SCHWEIZER SERVICE NOTICE

NOTICE NO. N-9.2
DATE 3 October 1977
PAGE 1 OF 7

SUBJECT: INSPECTION - POSSIBLE RETIREMENT, MAIN ROTOR BLADE

MODELS AFFECTED: All 269A, 269A-1, 269B and TH-55A Helicopters

Figure 1. Main Rotor and Root Fitting Cross Section

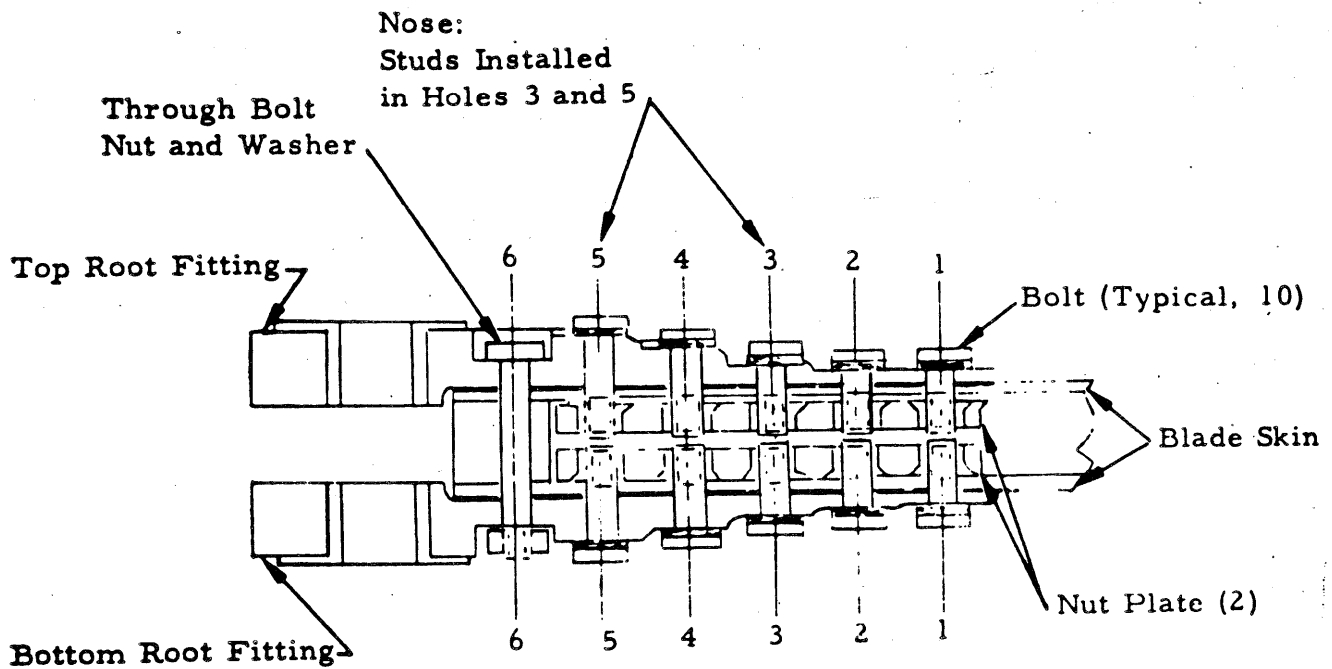
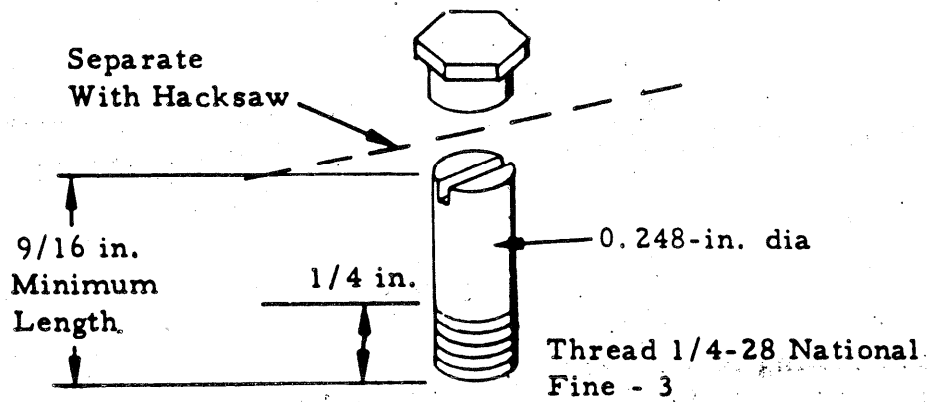
- a. Using hacksaw, remove heads from two NAS bolts.
(See Figure 1)
- b. Using hacksaw, cut screwdriver slot on unthreaded end of bolt and deburr.
- c. Determine that compliance with requirements of Service Information Notices N-46 dated 18 April 1968, or N-47 dated 18 April 1968 has been accomplished.

d. Remove root fitting retaining bolts 3 and 5 from top of blade (See Figure 1).

Figure 2. Main Rotor Blade Root Fitting Removed

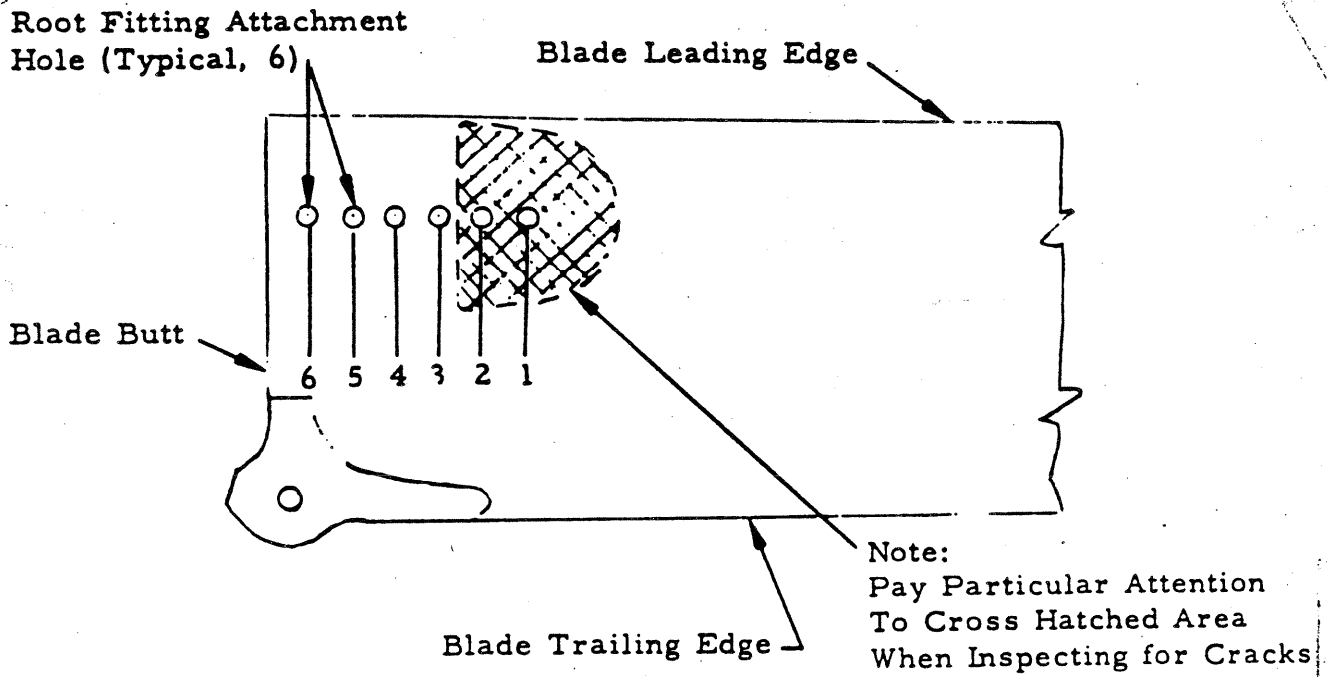
j. Inspect for cracks, holes 1 through 6, paying particular attention to 1 and 2. (See Figure 2)

While inspecting the blade holes for hairline cracks, examine the area at the forward and aft sides of the holes; and at both the skin surfaces and the inside of the hole itself, including the spar.
